SUSQUEHANNA RIVER BASIN
LAKE STRAUSE DAM
LAKE STRAUSE INCORPORATED

NDI NO. PA-01010,
DER NO. 38-068

LEBANON COUNTY, PENNSYLVANIA
PHASE I INSPECTION REPORT
NATIONAL DAM INSPECTION PROGRAM

OVERVIEW OF DOWNSTREAM SLOPE NO. - 4

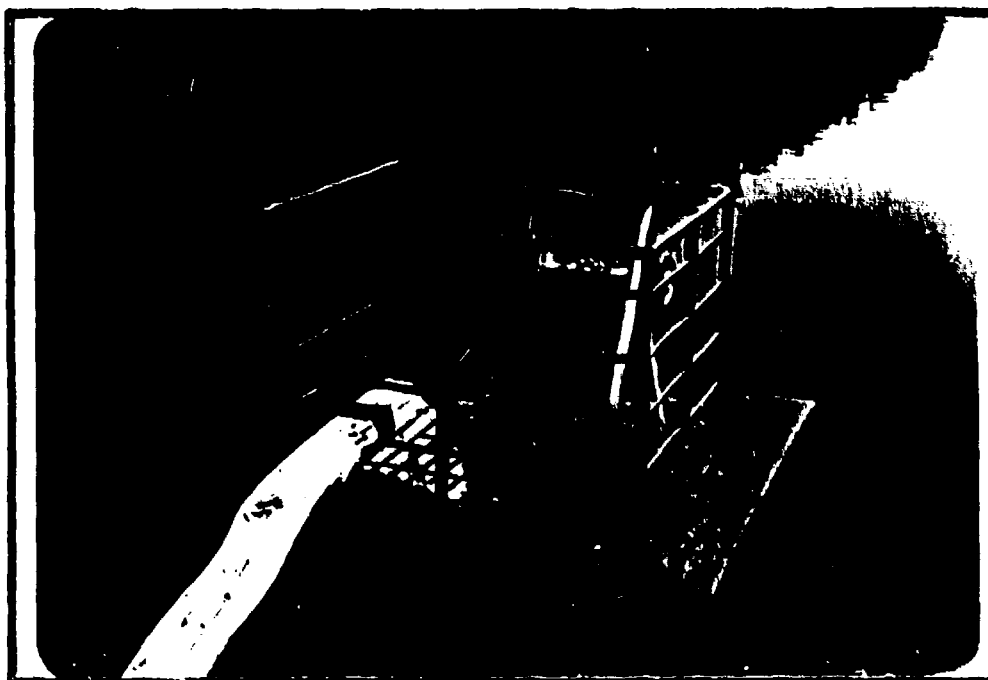
The embankment has a good appearance. Some bare areas on the downstream slope (Photograph No. 3) should be reseeded.

1. That provisions be made to increase the spillway capacity.
2. That the bare areas on the downstream slopes be reseeded.
3. That the drop inlet structure be inspected for structural adequacy after the reservoir has been lowered.

DROP INLET STRUCTURE NO. - 5

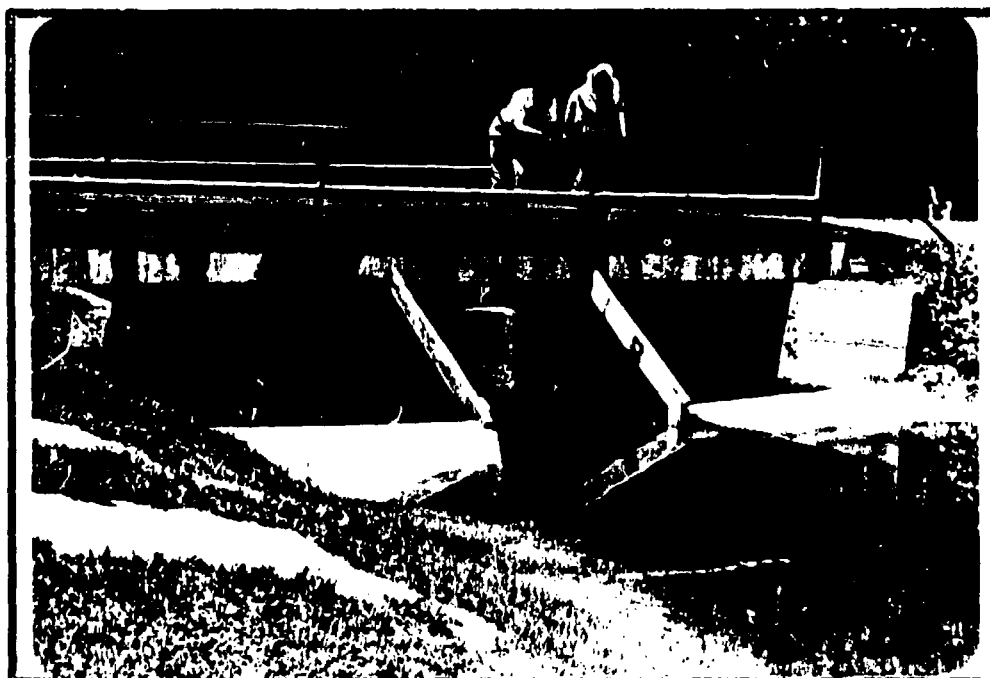
The poles in the spillway should be secured by means other than the struts in order to reduce the chance of obstructing flow during high floods. It is recommended that the drop inlet structure be inspected for structural soundness the next time the reservoir is lowered.

It was also noted that there was a wall in the drop inlet structure. Water appeared to be ponding on the upstream side of this wall, indicating that either the opening through the wall was obstructed, or the size of the opening was less than the indicated 3 feet.

OUTLET OF DROP INLET STRUCTURE NO. - 6

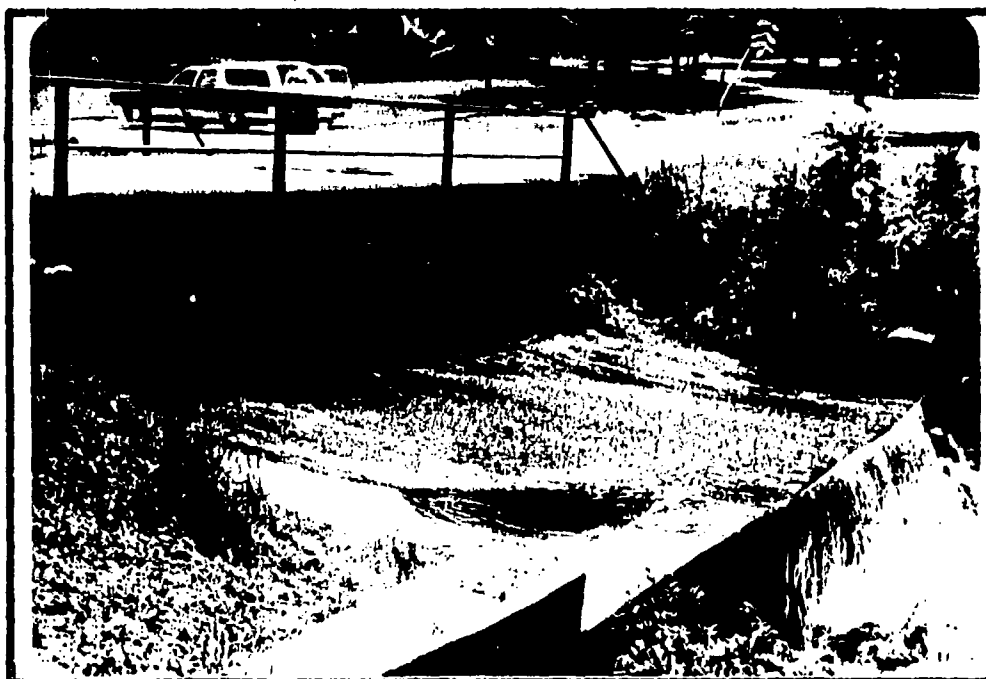
The second outlet for this reservoir is a drop inlet structure located near the right abutment. The inside plan dimensions for this structure are 3.7 feet by 4.5 feet. Gratings are located over the opening (Photograph No. 5) and a handrail sits on top of the concrete walls. A 3.0 by 3.0 foot wooden gate located on the upstream side of the outlet structure can be opened to lower the reservoir level. According to the owner's representative, the chain to raise this gate and the gate were repaired in 1980. Water was flowing into the inlet at the time of inspection. Probing indicated that a concrete baffle wall is located over a part of the height. Inside horizontal steel framing was installed in 1980 to strengthen the structure. The outlet for this structure is a 36-inch concrete pipe (Photograph No. 6).
